Atherton Hospital Redevelopment
Corner Jack and Louise St
Atherton
QLD 4883 Australia

MAIL TYPE	MAIL NUMBER	REFERENCE NUMBER
General Correspondence	FKG-GCOR-008327	FKG-RFI-001227

Re: URGENT - Level 1 Rectification Alternative

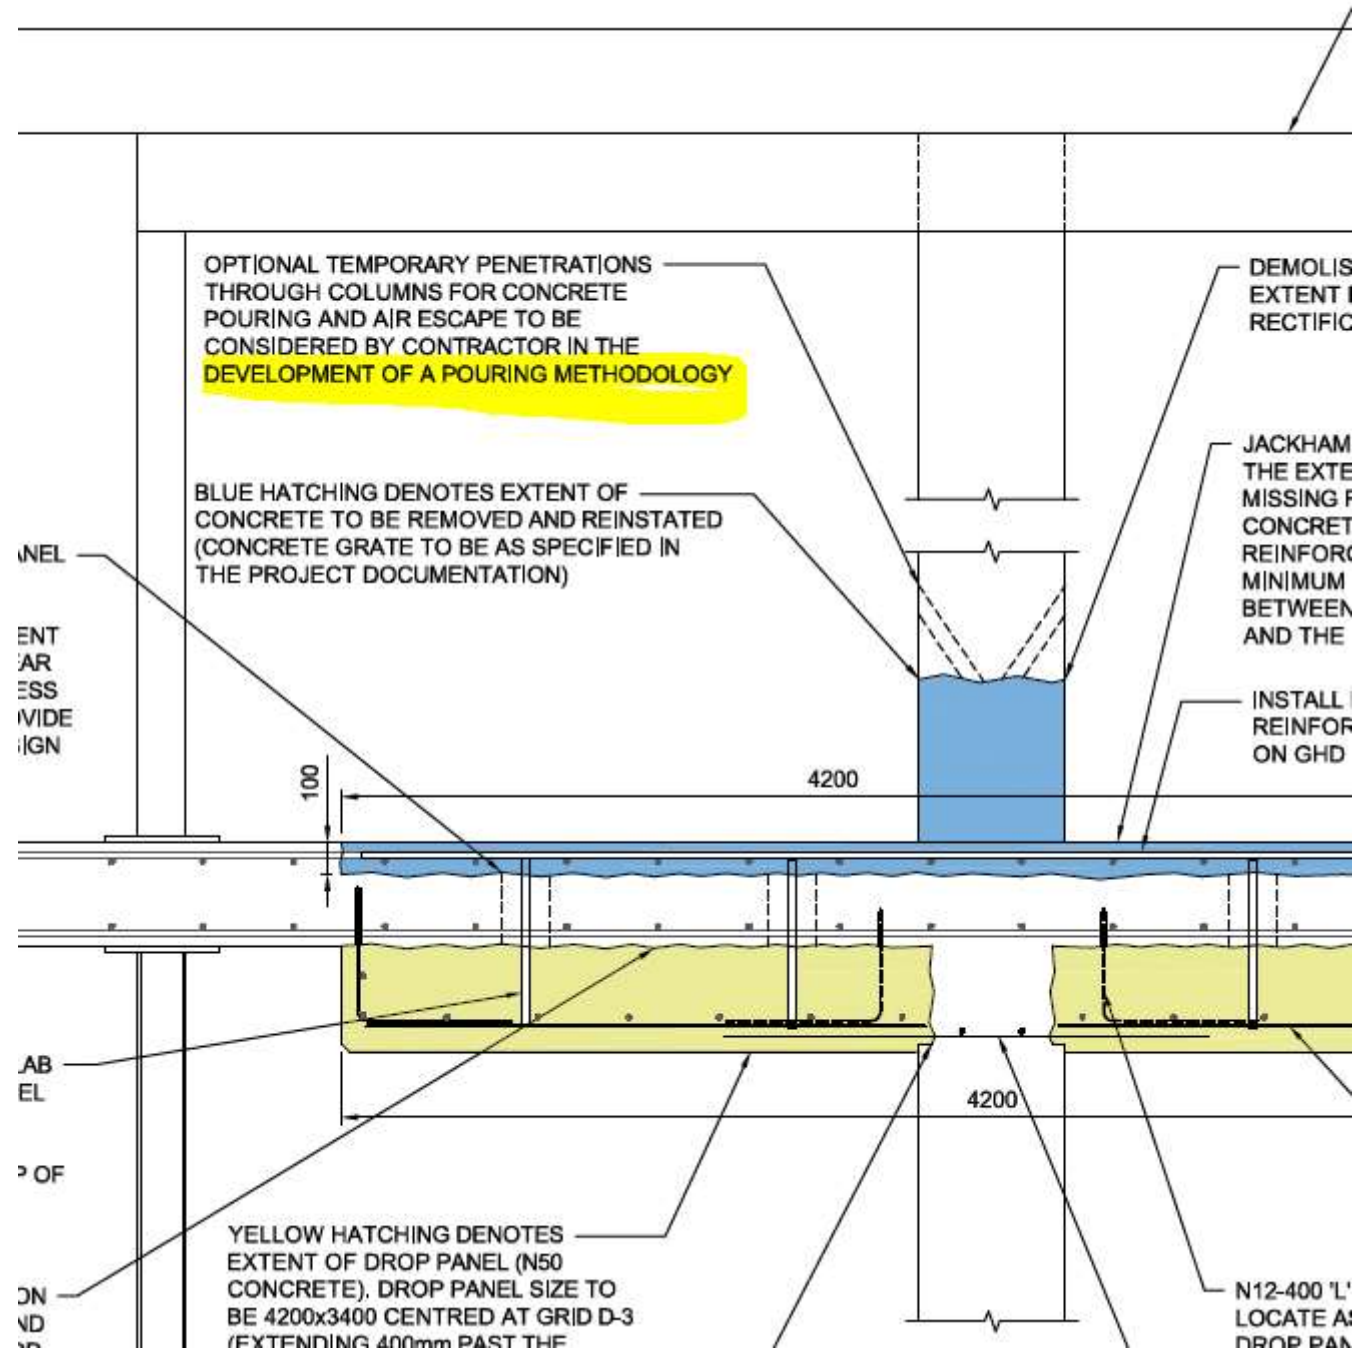
Please find attached a sample photo of the scabbling. The methodology for this scabbling is to etch the underside of the slab 10mm deep with a saw cut and then using the jackhammer to roughen up the area. FKG will continue with this scabbling method moving forwards.

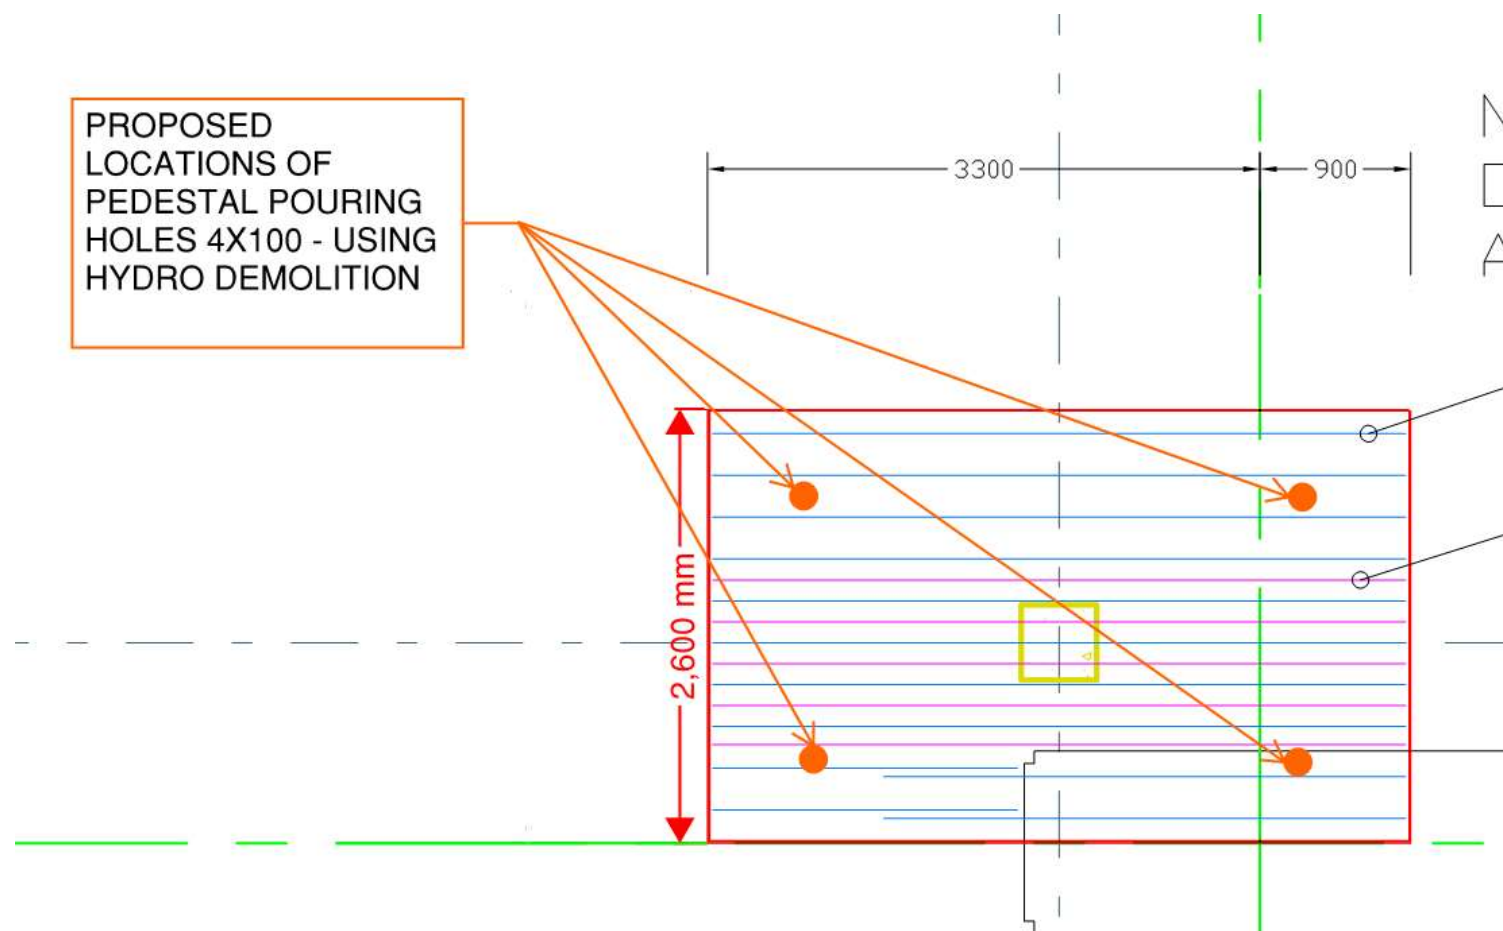
Please see below the 4 core hole locations proposed by FKG. Please note FKG would like to use hydro-demolition in these locations to ensure that no reinforcement is damaged and allow for a larger opening. The larger 100mm opening would allow for a concrete pump hose to get through the hole and be able to moved to ensure even and correct distribution of the concrete. This will also allow for the vibe to help move around the concrete to ensure no air pockets.

Please review proposal above and comment..

Hi Brendan,
please find attached for construction rectification detail.
With regards to the information provided by FKG:
1. number of holes required is 12 and not 4 as noted below by FKG. We have attached a sketch showing indicatively the location of these holes.
2. Can FKG please confirm shrinkage parameters of the proposed concrete mix (we have not been able to find this information in the document provided).
Regards

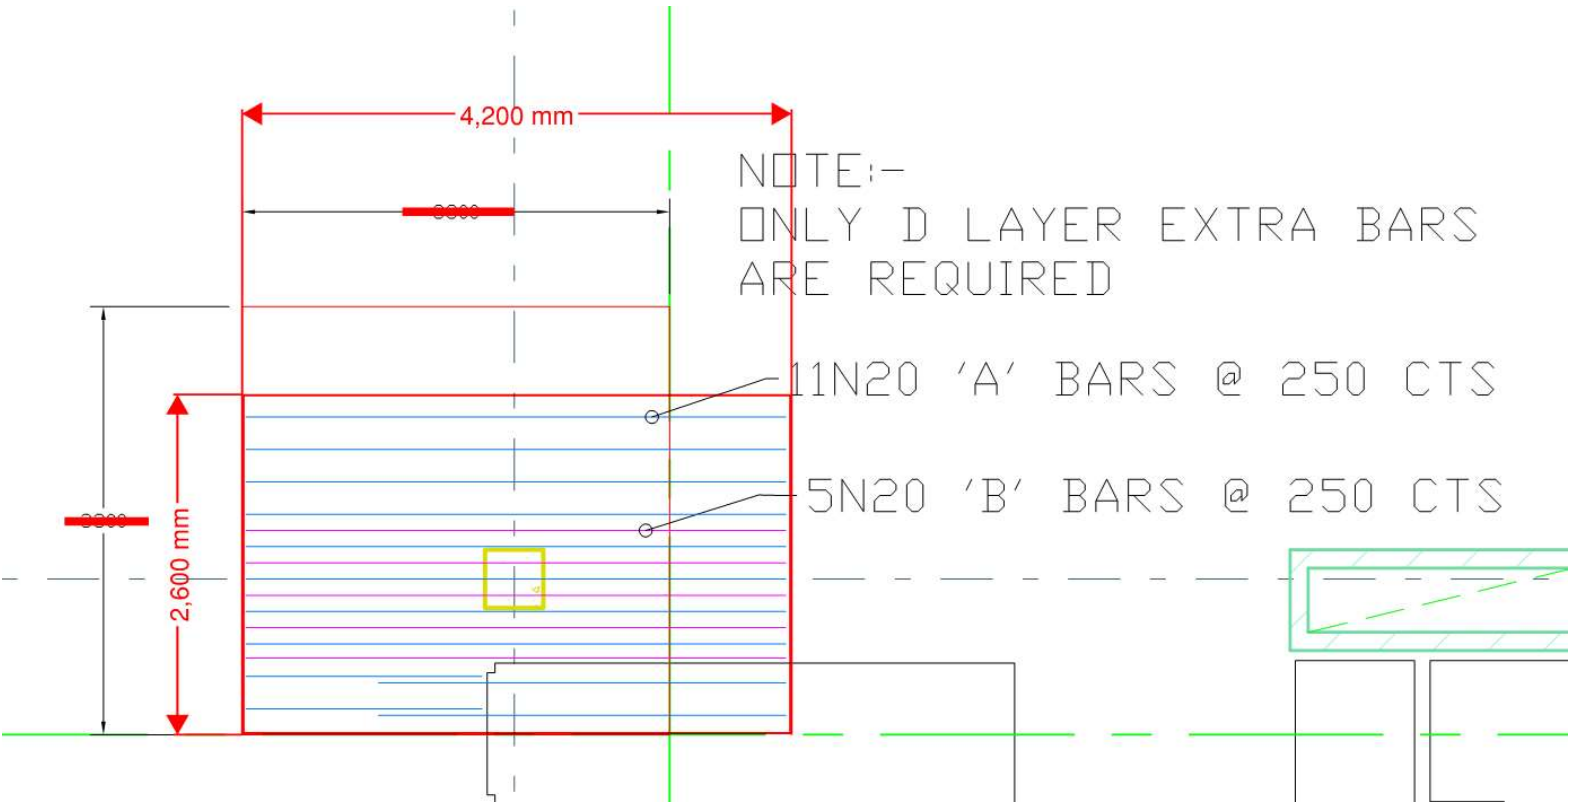
As discussed on the phone with Daniele this afternoon, please confirm if the below area of proposed demolition (4.2m x 2.6m) and potentially pedestal could be adopted during these rectification works.

The proposed demolition extent is acceptable. It is understood that on the southern side of grid 3 the demolition will extend up to the construction joint.

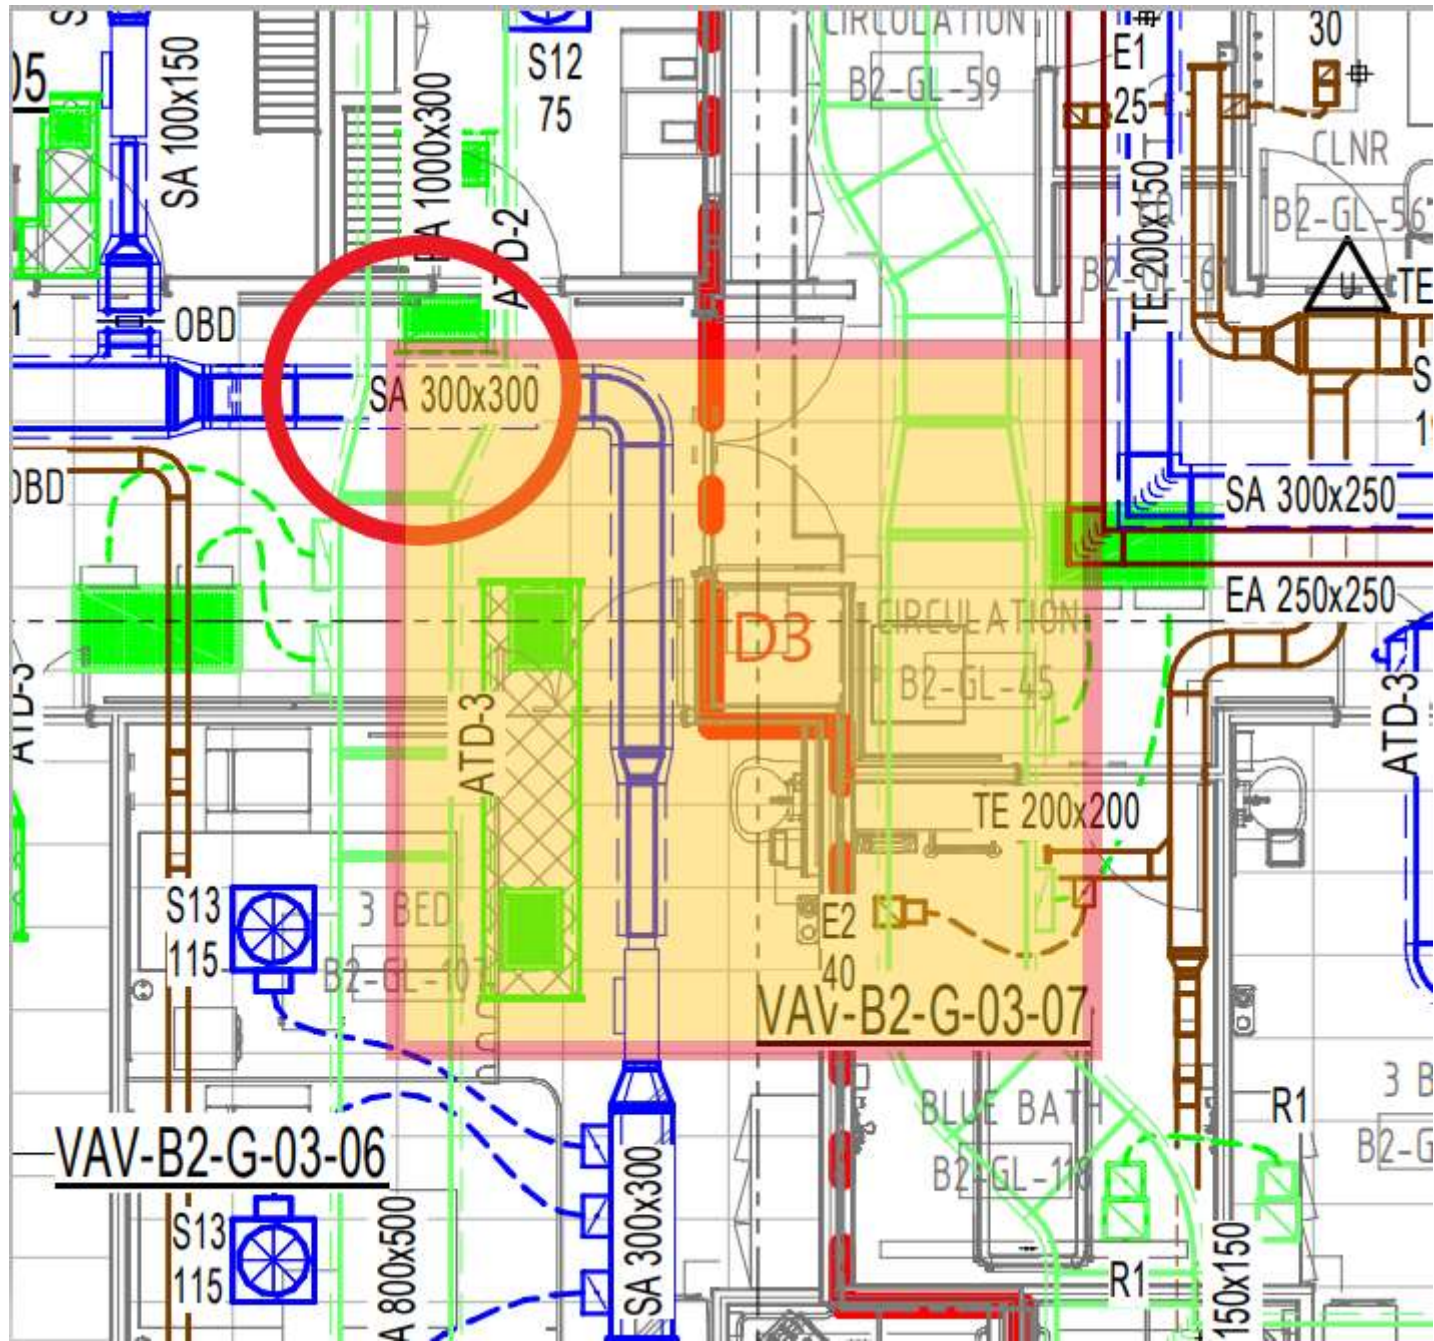
We note that it will have a minor clash with some of the mechanical ductwork shown circled below.

However we anticipate that this will be coordinated between yourselves and VAE?
